Access Compliance Report Public Rights-of-Way (Curb Ramps)

Main Street: DONOVAN_RD Cross Street: KITTRICK_DR Location: E

ADA ID: RPAT211202090135 Ramp Type: Type 1 - Perpendicular Diagonal Initial Pass/Fail: Pass Overall Compliance: No Severity Score: 18

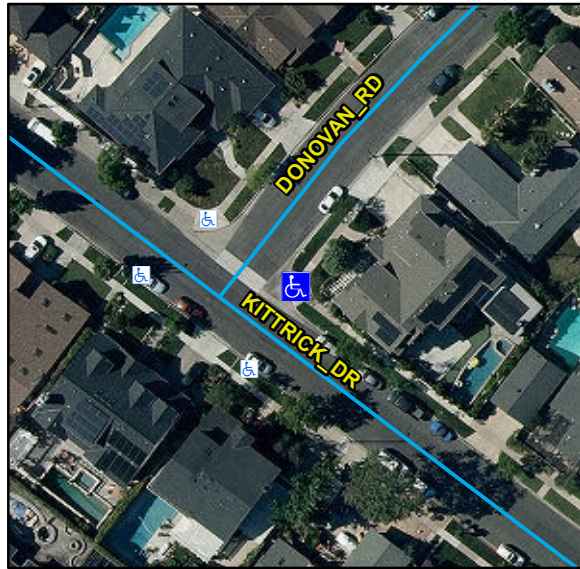
Compliance	Description	Data	Compliance	Description	Data
N/A	Ramp Length (in)	85	N/A	Flare Type LT	
Yes	Ramp Width (in)	53			Sloped
Yes	Ramp Run Slope (%)	7.3	N/A	Flare Slope LT (%)	6
Yes	Ramp Cross Slope (%)	1.1	N/A	Flare Traversable LT	No
N/A	Landing Present	Yes	N/A	Flare Type RT	
N/A	Landing Length (in)	35			Sloped
Yes	Landing Width (in)	48	N/A	Flare Slope RT (%)	6.3
No	Landing Run Slope (%)	2.7	N/A	Flare Traversable RT	No
Yes	Landing Cross Slope (%)	1.7	No	DWS Provided	No
N/A	Landing Movement Obstructed?	No	N/A	DWS Contrast	N/A
	Landing Movement Type	N/A	N/A	DWS Length (in)	N/A
N/A	Landing Shared	No	N/A	DWS Full Width	N/A
N/A	Clear Space	Yes	N/A	DWS Offset Left (in)	N/A
N/A	Clear Space To Crosswalk (in)	48	N/A	DWS Offset Right (in)	N/A
N/A	Marked Crosswalk 1	No	N/A	Marked Crosswalk 2	No
	Crossing 1 Direction	NE		Crossing 2 Direction	SE
	Marked Crosswalk 1 Width (in)	N/A		Marked Crosswalk 2 Width (in)	N/A

N/A	Ramp Inside Crosswalk 1	N/A	Yes	Ramp Inside Crosswalk 2	N/A
	Crossing 1 Slope (%)	3.1		Crossing 2 Slope (%)	5.7
	Crossing 1 Cross Slope (%)	0.4		Crossing 2 Cross Slope (%)	0.3
Yes	Gutter Ponding	No	No	Curb Slope	7
Yes	Gutter Lip Height (in)	0		Road Run Slope (%)	0.7
Yes	Gutter Run Slope (%)	2.9		Road Cross Slope (%)	0.7
No	Gutter Cross Slope (%)	2.1			
Yes	Overall Surface Condition: Acceptable		No	Perp Joint Present	No
	Cross Gutter Present?	Yes		Spandrel Present?	Yes
	Replace Cross Gutter?	No		Replace Spandrel?	No

Remove & Replace Curb Ramp With Two New Directional Ramps or Equivalent. Remove & Replace Gutter.
